Immingham Eastern Ro-Ro Terminal

Deadline 8 Submissions

**Associated Petroleum Terminals (Immingham) Limited and Humber
Oil Terminals Trustee Limited**

Responses to Examining Authority’s Further Written Questions (ExQ4)

Figure 1: Design vessel simulations run paused prior to alliding with IOT River Berth at 1.26 knots.

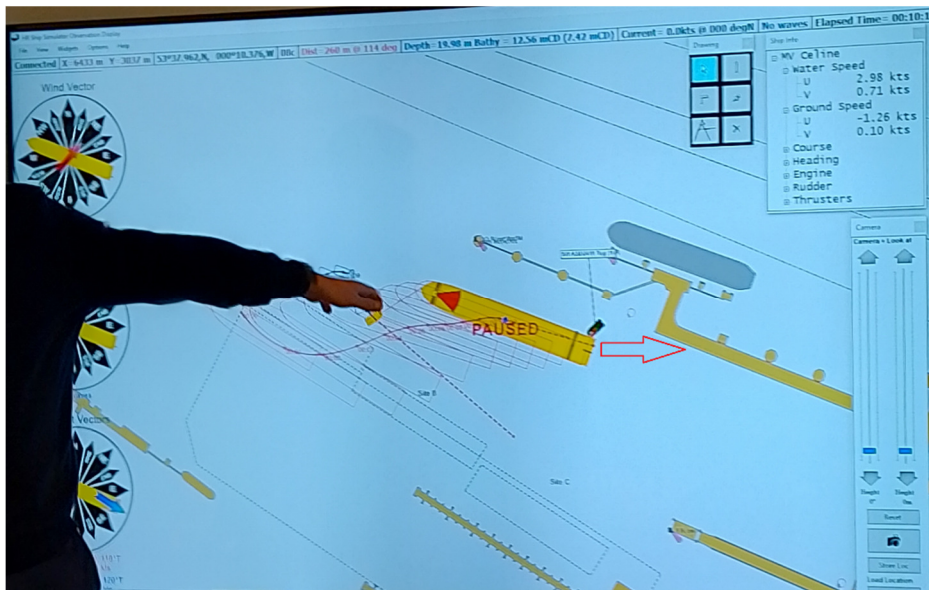
14. In respect of the simulation runs of the vessel more closely resembling the design vessel, the results demonstrated a significant loss of control. Of eight runs using that vessel, six (three-quarters) resulted in the vessel significantly out of control². Further it was evident in certain situations (including in predominant SW wind) the runs resulted in the loss of control of the design vessel and it drifting towards the inside of IOT river berths and the IOT Trunkway to seaward of the IOT Finger Pier – areas which have been afforded no impact protection by the Applicant.³

15. It is apparent from these late simulations that, should the IERRT development go ahead as planned, impact protection is absolutely required for the whole of the IOT infrastructure (see figure below showing the errant IERRT design vessel about to strike the IOT river berths with consequential damage to vessels alongside).

Figure 3: IERRT NRA Figure 24 Tolerability Matrices

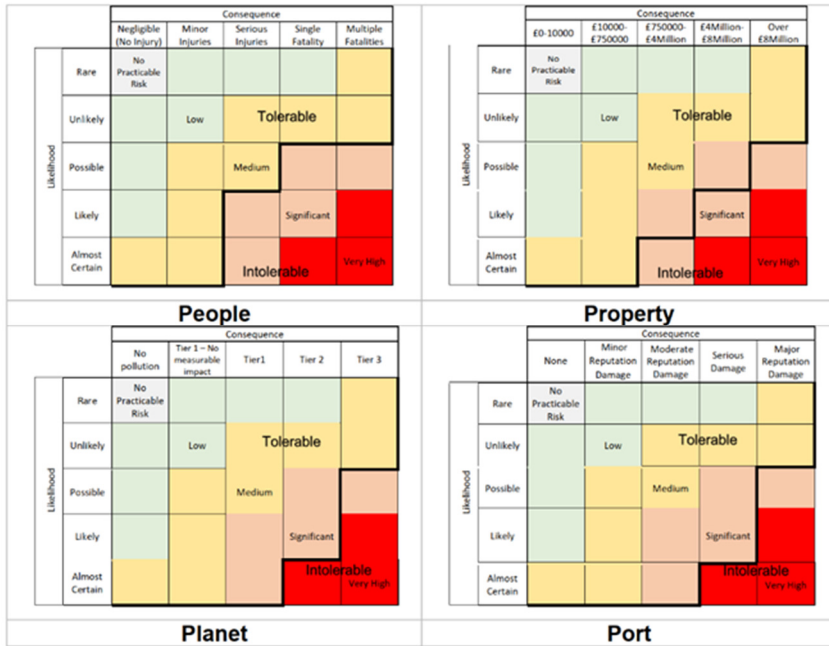
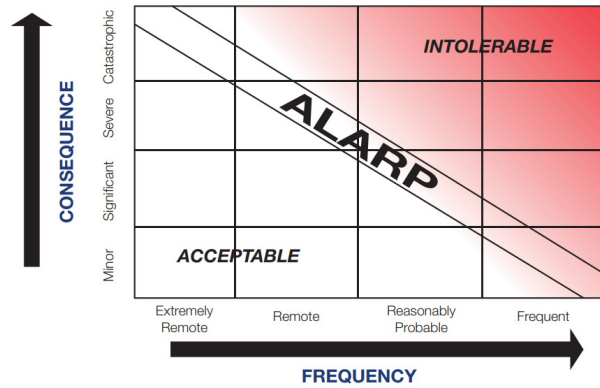
73. However, the tolerability matrices presented in Figure 24 of the IERRT updated NRA (see figure below) have not been updated to classify an ALARP zone. This is at odds with the Port Marine Safety Code Guide to Good Practise [REP1-016] or MCA MGN 654 [REP1-017], which the Applicant states its methodology is based on, both of which clearly provide example matrices with "Intolerable", "ALARP" and "Acceptable" zones depicted. This approach is adopted by the HSE, see IOT sNRA para. 183, which references the HSE's Reducing Risks Protecting People. Further the IOT Operators' sNRA and the DFDS' NRA, both clearly characterise and define ALARP zones.

74. Not only therefore has the Applicant created arbitrary thresholds for tolerability, it has also failed to provide any threshold for ALARP which is also an arbitrary threshold. It has effectively chosen qualitative risk thresholds to define its risk appetite which do not relate to any published guidance and further put no limits to the approach taken to ALARP. Effectively the Applicant has defined what it considers safe or not without any transparency or clear parameters.
